**Errata for the
PCI Express[®] Base Specification
Revision 3.1,
Single Root I/O Virtualization and
Sharing Revision 1.1,
Address Translation and Sharing
Revision 1.1, and M.2 Specification
Revision 1.0**

September 18, 2015

REVISION	REVISION HISTORY	DATE
1.0	First Release. Includes B208, A210, B211, B214 to B216, A217, B218 to B220, B224, B228 to B237, B242, B244, B246, B248 to B250, B252 to B264	2015-09-18

Figure 7-3: PCI Express Configuration Space Layout

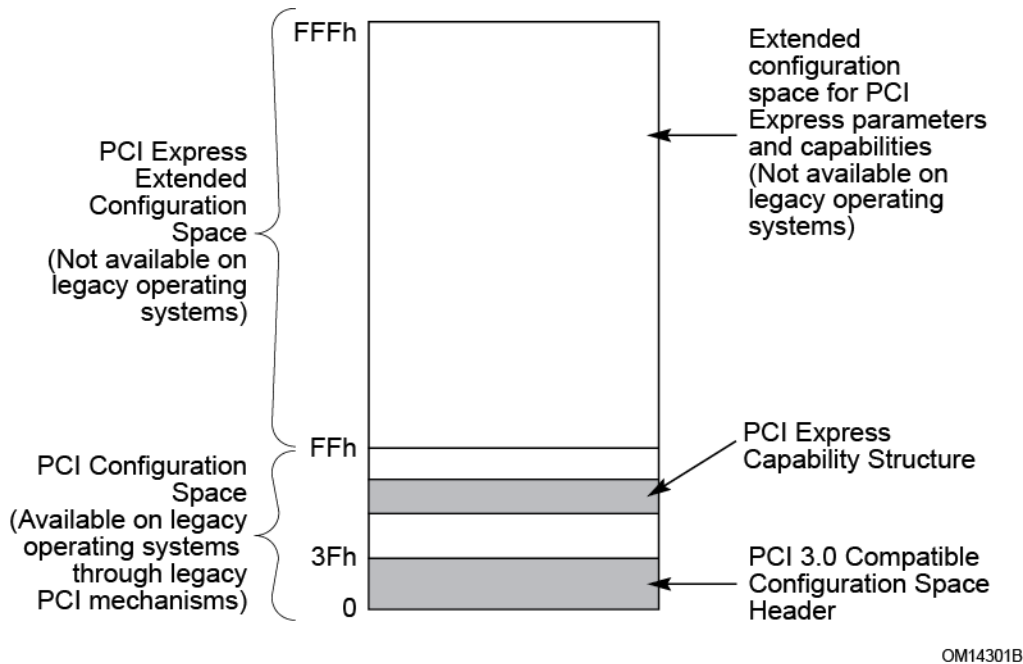
In Section 3.5.2.1, page 655, Figure 7-3, change text as following:

PCI Express
 Capability Structure
~~Capability needed by BIOS
 or by driver software on non
 PCI Express aware operating
 systems~~

so the figure becomes the following:

Figure 7-132: Secondary PCI Express Extended Capability Structure

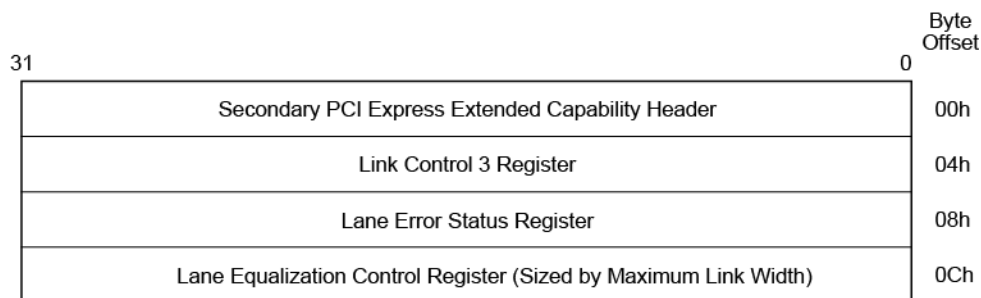
In Section 7.27, page 857, Figure 7-132, change the name of the field at offset 0Ch as follows:

Lane Equalization Control Register (Sized by Maximum Link Width)

so that the figure looks like:
